**BLOOMINGTON HEARING OFFICER
STAFF REPORT
Location: 523 West 7th Street**

**CASE #: V-28-24
/ VAR2024-09-0047
DATE: September 25, 2024**

REQUEST: The petitioner is requesting a determinate sidewalk variance to allow construction of a single-family dwelling without construction of a sidewalk along the Jackson Street frontage of the property at this time in the Residential Urban Lot (R4) zoning district.

SITE PLAN
IN LOT NUMBERED TWO HUNDRED EIGHTY (280) IN THE
ORIGINAL PLAT OF THE CITY OF BLOOMINGTON
MONROE COUNTY, INDIANA

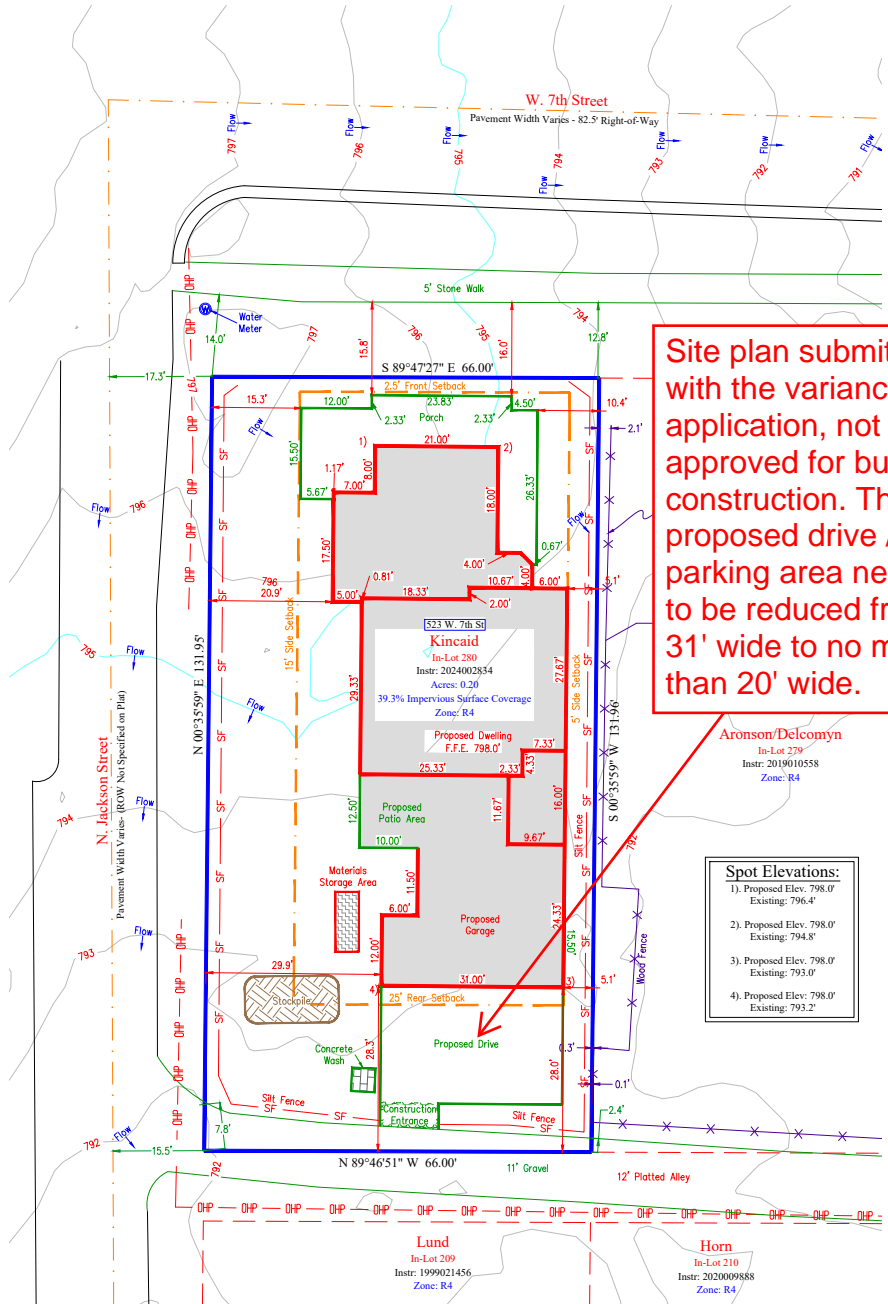
Site plan submitted with the variance application, not yet approved for building construction. The proposed drive / parking area needs to be reduced from 31' wide to no more than 20' wide.
